To: Kristopher Byrd, Well Construction and Compliance Section Manager
From: Travis Kelly, Well Construction Compliance Coordinator
Subject: Review of Water Right Application G-19075
Date: February 28, 2022

Groundwater Application Review Summary Form

Application # G- 19075

TO: Water Rights Section Date 2/23/2022
 FROM: Groundwater Section Stacey Garrison/Travis Brown
 Reviewer's Name
 SUBJECT: Application G- 19075 Supersedes review of _____
 Date of Review(s)

Water-Level Measurements in Nearby Wells

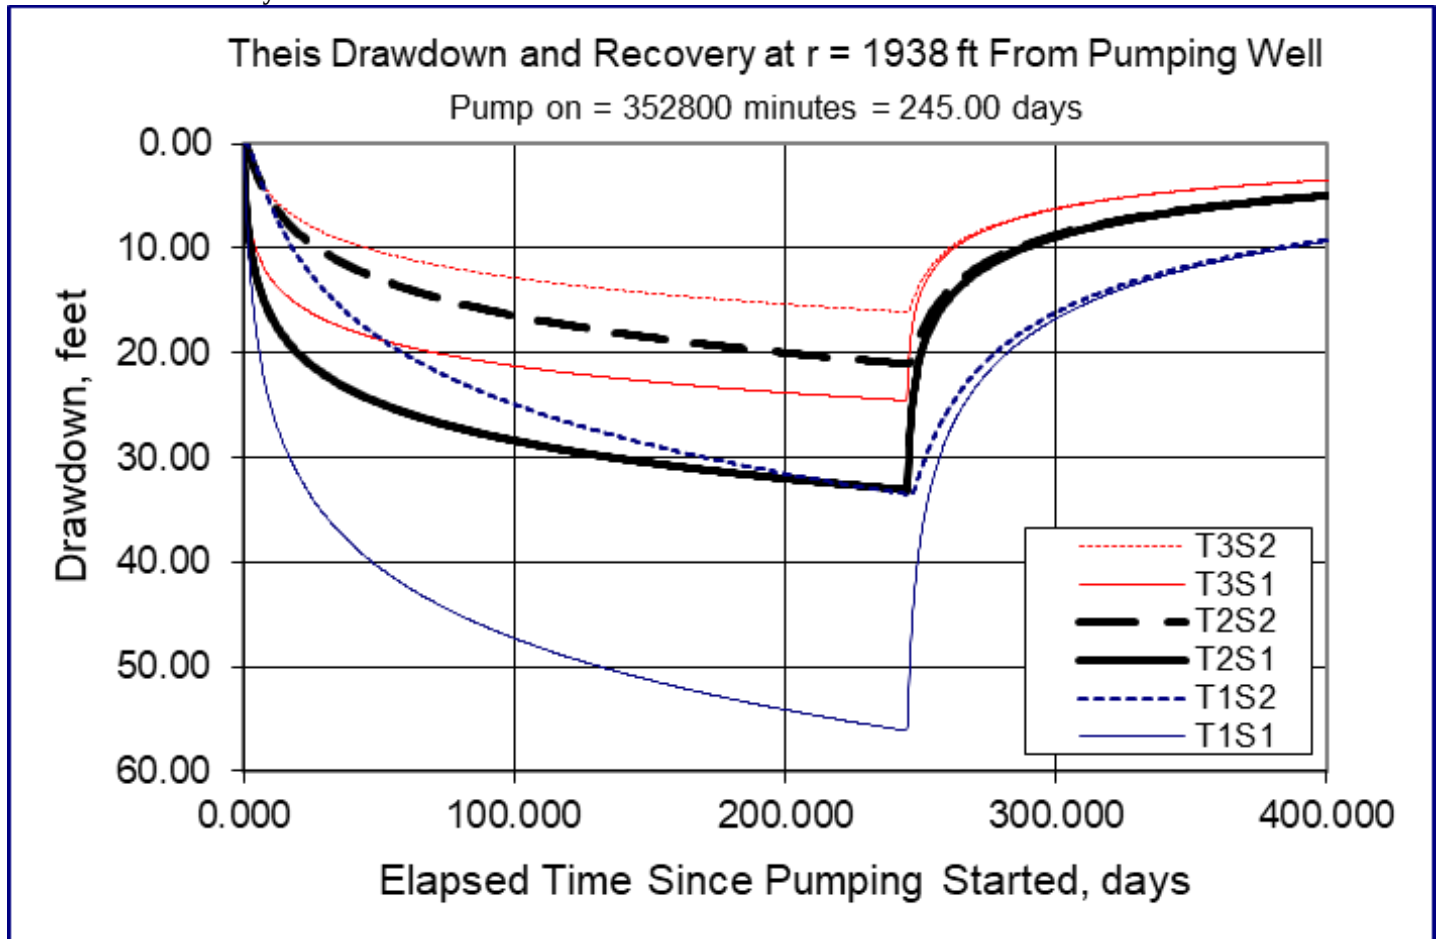
Water level trends for nearby (0.2-3 miles from POAs) wells that utilize alluvial aquifers appear to be declining at a steady rate (see [Water Level Measurements in Nearby Wells](#)). About half of the wells show low levels of steady decline, ranging from 3 to 8 ft in the last 10 years: CLAC 20566, CLAC 54578, CLAC 14260, CLAC 53992, CLAC 57287, CLAC 66134, CLAC 66672, CLAC 70590. Water levels in CLAC 64836 have declined nearly 10 ft in the last 10 years. The remaining 6 wells in the surrounding sections show stable water levels. **Given the pattern of steady, widespread water level declines, it is likely that the proposed use is beyond the capacity of the resource.**

Theis Drawdown Analysis-Well 1

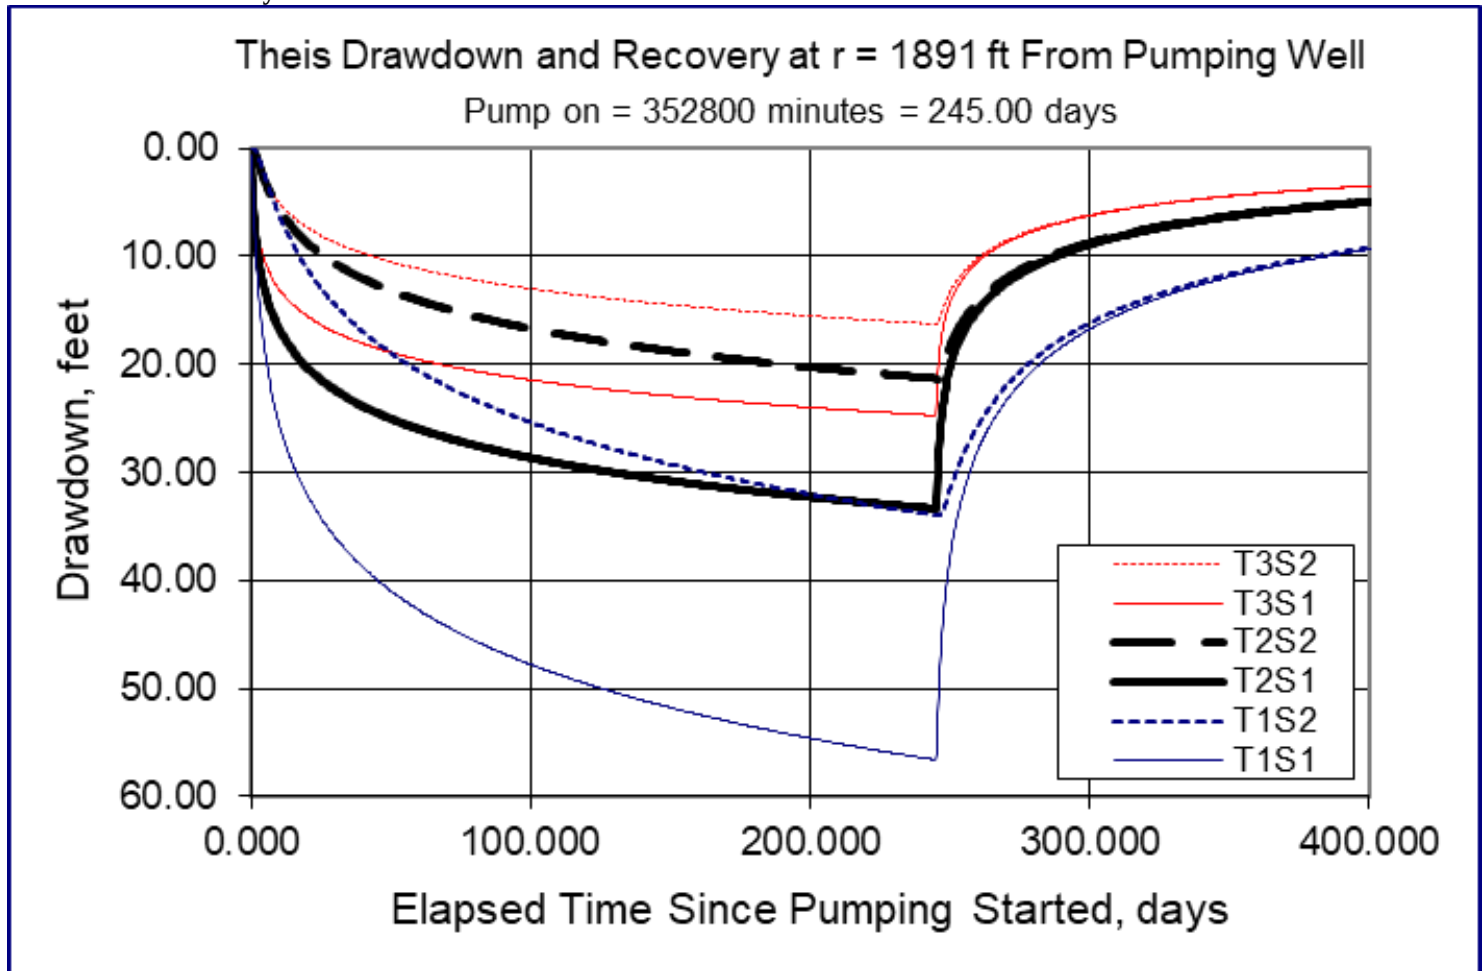
The nearest groundwater user to Well 1 is CLAC 12818 (an exempt domestic well) is 1,938 ft northeast of the POA, at an elevation of ~263 ft msl. CLAC 12818 is completed to a depth of 51 ft. It is likely the proposed use would cause some degree of well-to-well interference with CLAC 12818. To assess the degree of drawdown, a Theis drawdown analysis was conducted for the proposed use (see [attached Theis Drawdown Analysis-Well 1](#)). Results indicate that the proposed use is not likely to cause well-to-well interference with CLAC 12818 that exceeds the threshold under the standard condition for alluvial aquifers in the Willamette Basin.

Radial distance from pumping well (r)=1,938 ft [estimated radial distance to nearest user, CLAC 12818]

Pumping Rate (Q)= 0.56 cfs (255 gpm) *

Aquifer Transmissivity ($T1$)= 2,954.6 gpd/ft (395 ft²/day), ($T2$)= 5,572.6 gpd/ft (745 ft²/day), ($T3$)= 7,928.8 gpd/ft (1,060 ft²/day)

Storativity ($s1$) = 2×10^{-4} , ($s2$) = 2×10^{-3} [Conlon et al 2005, Tables 1 and 2 values for Central MSU]

Total pumping time = 245 days

*The full pumping rate could not be utilized continuously for the entire 245-day period of use without exceeding the 276.5 ac-ft maximum allowed duty. For the maximum allowed duty of 276.5 ac-ft, continuous pumping would occur for 245 days at a rate of 0.57 cfs (255 gpm).

Based on this analysis of the available data and under the assumptions previously identified, groundwater for the proposed use will not likely be within capacity of the resource; if a permit is issued for this application, the conditions in B1(d)(i) and B2(c) are recommended to protect senior users and the groundwater resource.
